Access Compliance Report

Public Rights-of-Way

(Curb Ramps)

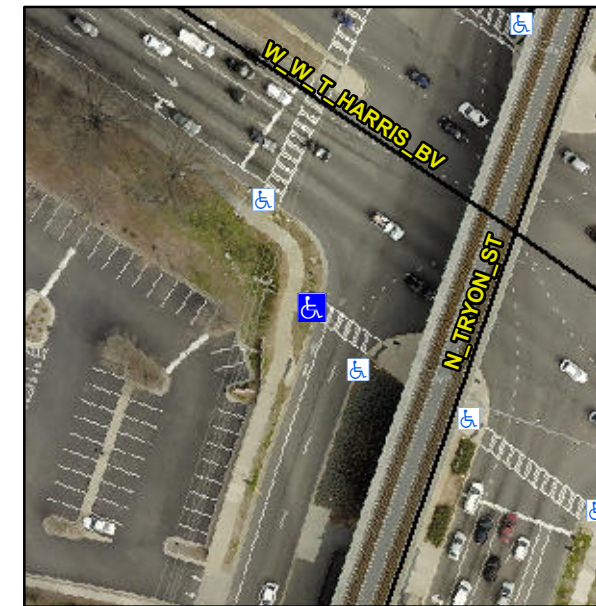
Not Found, R304.2.2

Compliance	Description	Data	Compliance	Description	Data
N/A	Ramp Length (in)	123.0	No	Ramp Slope (%)	8.9
Yes	Ramp Width (in)	96.0	Yes	Ramp XSlope (%)	1.6
N/A	Flare Type LT	N/A	N/A	Flare Type RT	N/A
N/A	Flare Slope LT (%)	N/A	N/A	Flare Slope RT (%)	N/A
N/A	Flare Traversable LT?	N/A	N/A	Flare Traversable RT?	N/A
N/A	Landing Length (in)	N/A	N/A	DWS Provided?	N/A
N/A	Landing Width (in)	N/A	N/A	DWS Contrast?	N/A
N/A	Landing Slope (%)	N/A	N/A	DWS Length (in)	N/A
N/A	Landing X Slope (%)	N/A	N/A	DWS Full Width?	N/A
N/A	Landing Curb? (Y/N)	N/A	N/A	DWS Offset (in)	N/A
N/A	Shared Landing?	N/A			
N/A	Gutter Ponding?	N/A	N/A	Gutter Slope (%)	N/A
N/A	Gutter Lip Ht (in)	1.0	N/A	Gutter X Slope (%)	N/A
N/A	Painted X Walk1?	No	N/A	Painted X Walk2?	N/A
	X Walk 1 Direction	To SE		X Walk 2 Direction	N/A
N/A	X Walk 1 Width (in)	N/A	N/A	X Walk 2 Width (in)	N/A
	X Walk 1 Slope (%)	2.4		X Walk 2 Slope (%)	N/A
	X Walk 1 X Slope (%)	2.0		X Walk 2 X Slope (%)	N/A

Remove & Replace Entire Ramp.
